Origination Form
Proposed Revisions to a Standard Plans Index

Originator:	Turley, Joshua	Index Number:	102-200
Date:	5/15/2025	Sheet Number(s):	All sheets
E-mail:	Joshua.Turley@dot.state.fl.us	Index Title:	TEMPORARY ACROW 300 SERIES DETOUR BRIDGE GENERAL NOTES AND DETAILS

Summary of the changes:

2026-27		FY 2025-26		TEMPORARY ACROW 300 SERIES DETOUR BRIDGE		INDEX		SHEET 8	
LAST REVISION		FDOT		GENERAL NOTES AND DETAILS		102-200		3 of 7	
11/01/23									
11/01/25									
REVISION		DESCRIPTION:

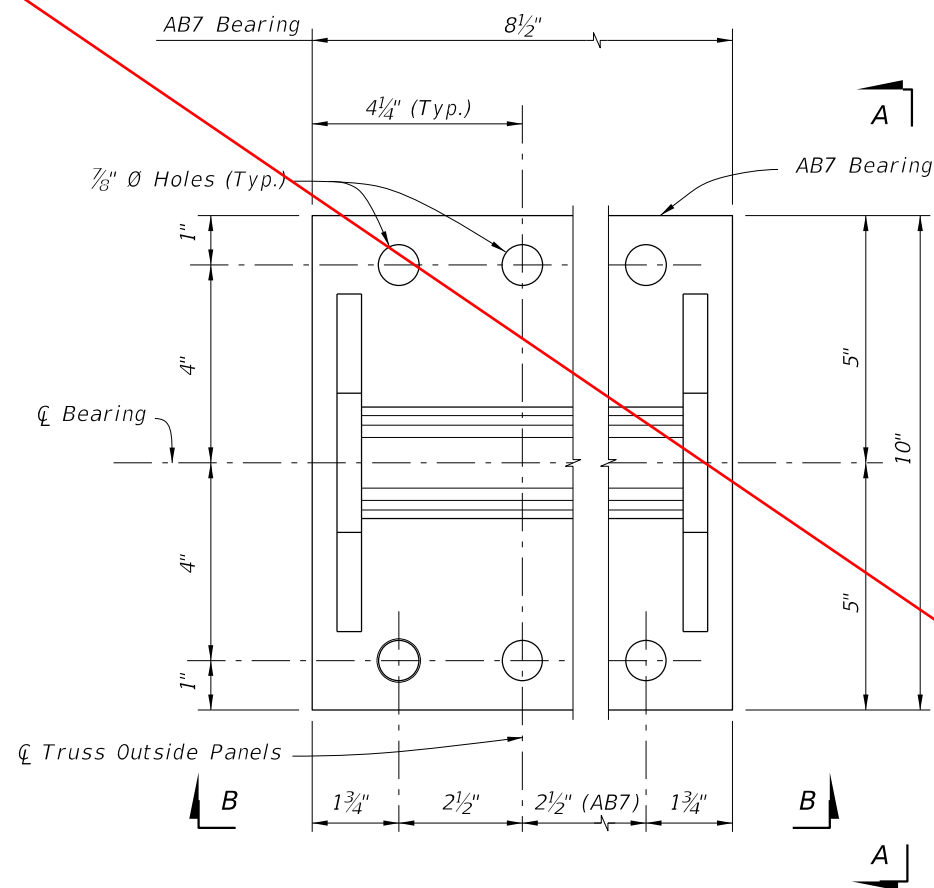
Sheet 1: Changed number of sheets
Sheet 2: Changed number of sheets
Sheet 3: Removed underside of expansion bearing dimension and added a note that it will be set in final design.
Sheet4: Removed the note that indicated FDOT will provide both the expansion and fixed bearings and changed it to just the ACROW AB7 bearing and added a sheet reference to it.
Sheet 5: Removed sheet
Sheet 6: Changed number of sheets
Sheet 7(NEW): Added an expanded set of details for the intermediate bearings instead of the abbreviated details on the old Sheet 5.
Sheet 8(NEW): Added an expanded set of details for the end bent bearings instead of the abbreviated details on the old Sheet 5.

Sheet 3: We dont actually know the underside dimension for the bearings until final design so it is inappropriate to ball park the dimension.
Sheet4: We are being more specific about what FDOT does and does not provide to the Contractor.
Sheet 5: Deleted sheet and added information with expanded details for clarity on new Sheets 7 and 8.
Sheet 7: Expanded details of the bearings add clarity.
Sheet 8: Expanded details of the bearings add clarity.

1. The dimension to be determined based on final design of substructure. Expansion bearings designed & detailed by Specialty Engineer and supplied by Contractor.

SHEET
5 of 7

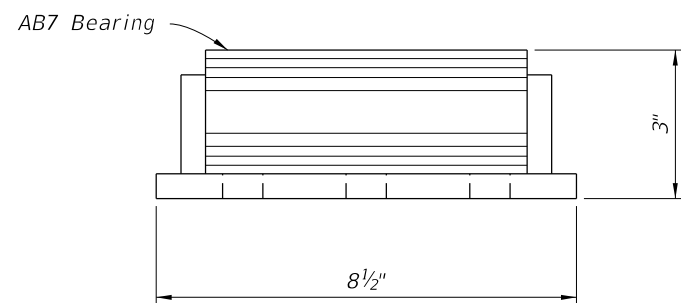
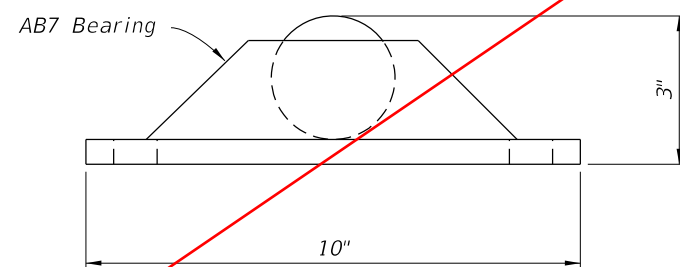
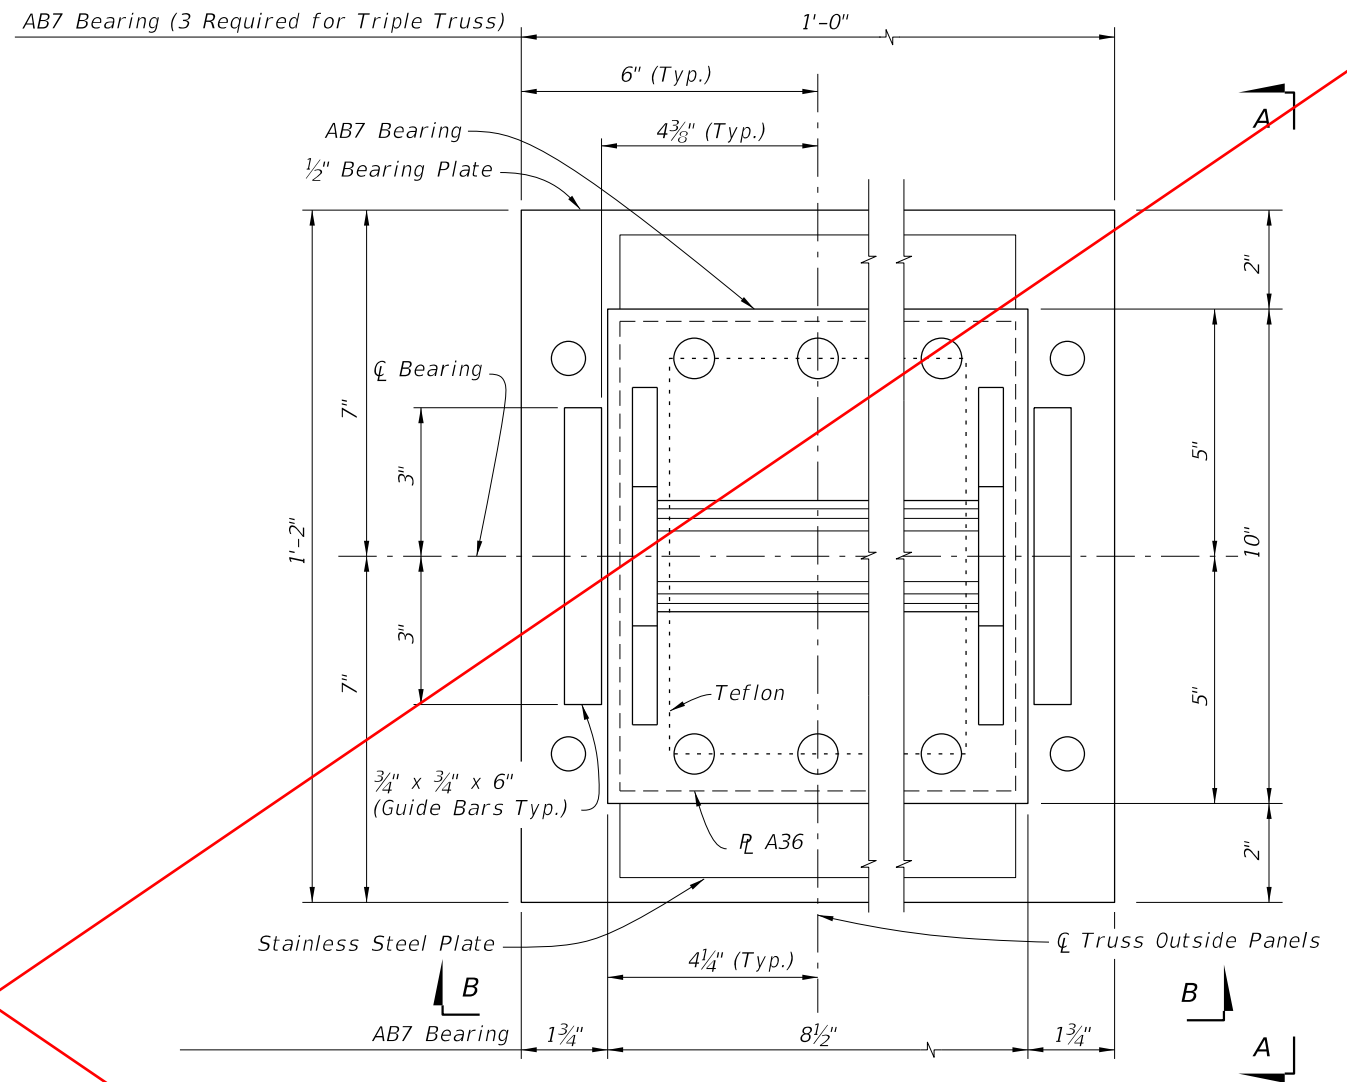
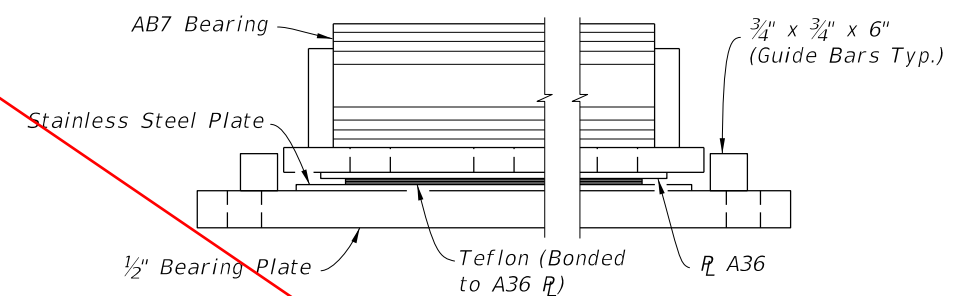
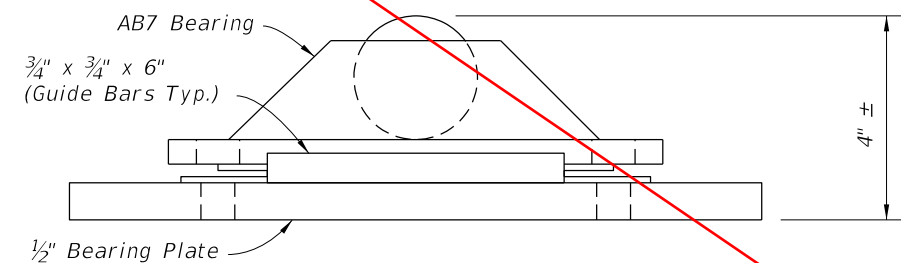
Remove Sheet

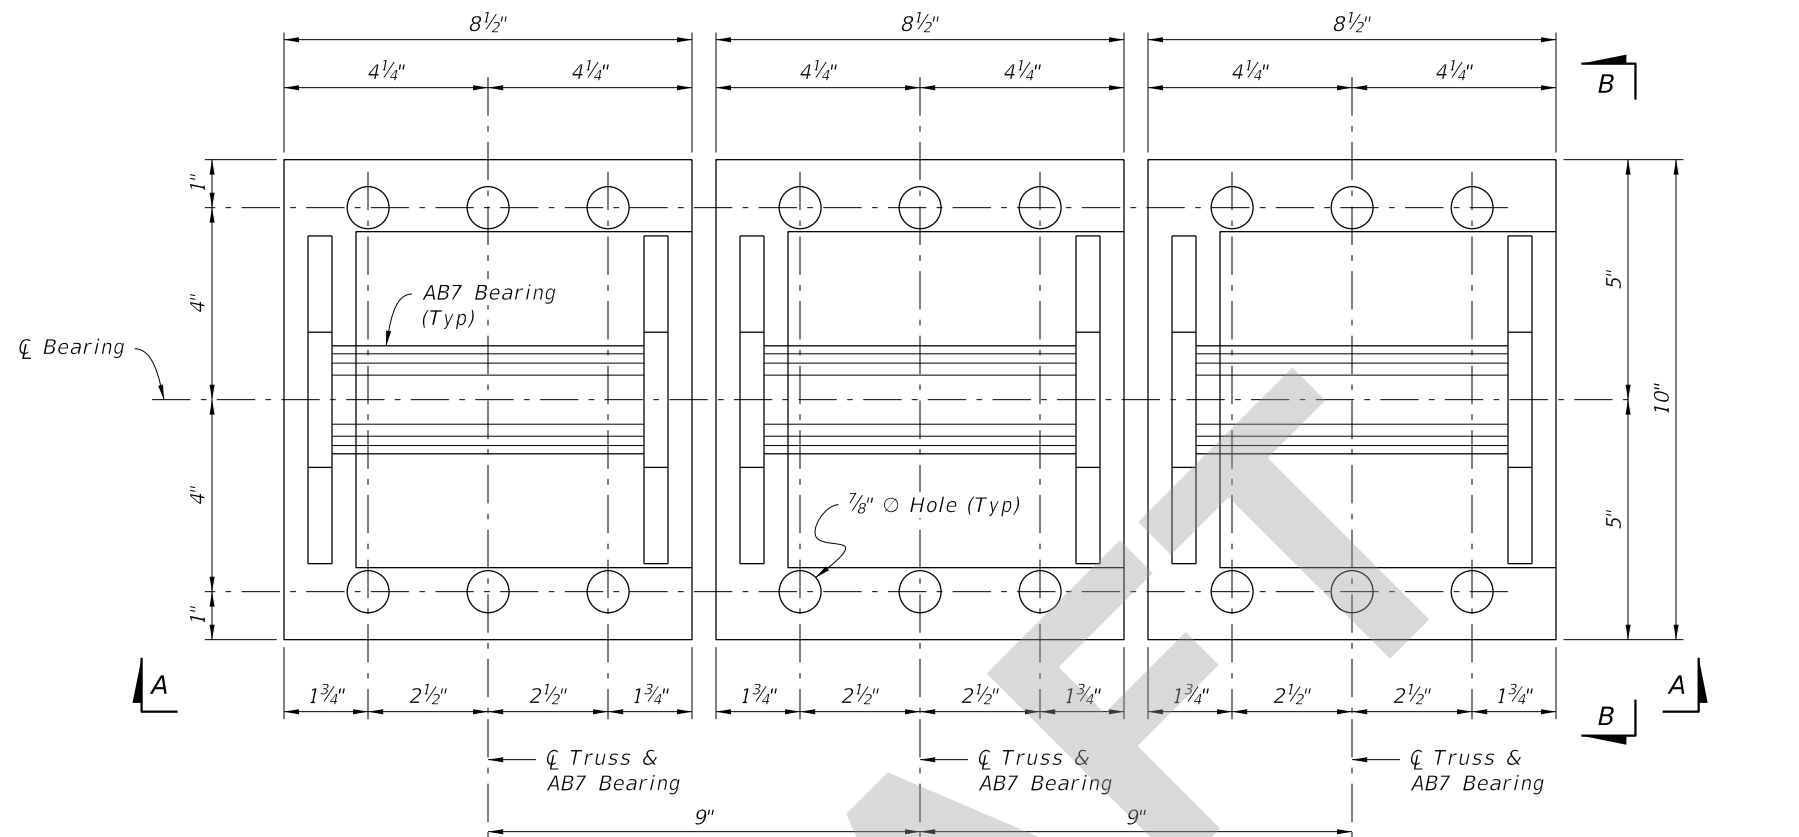
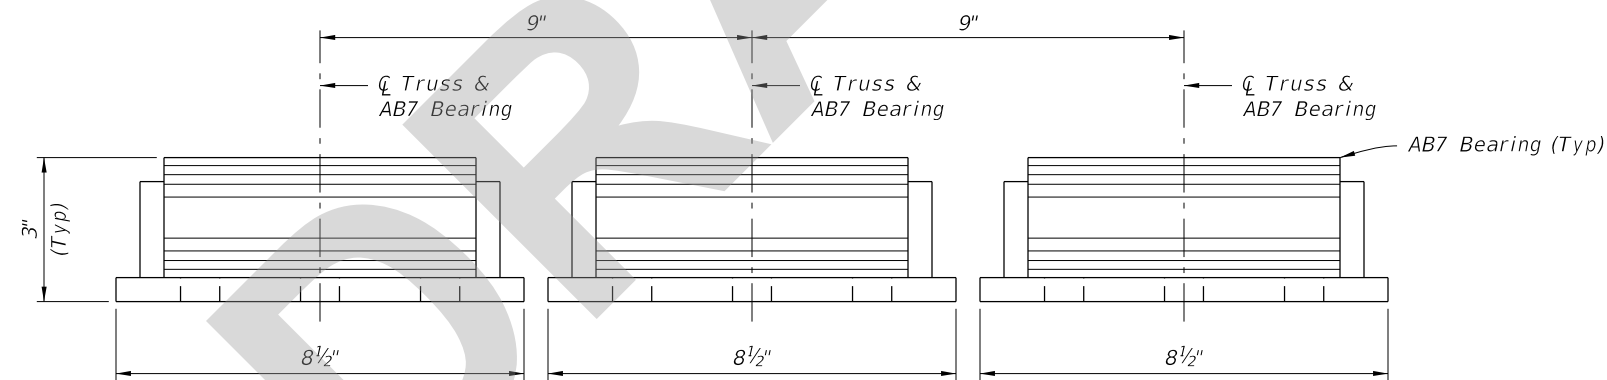
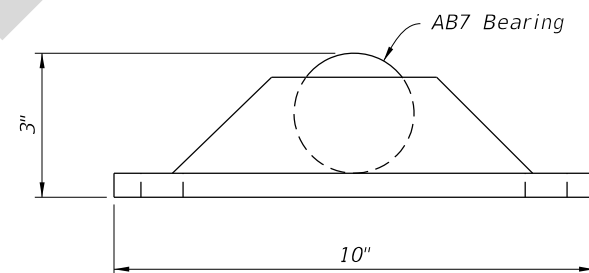
**NEW SHEET 7: Details for
Intermediate Bearings**
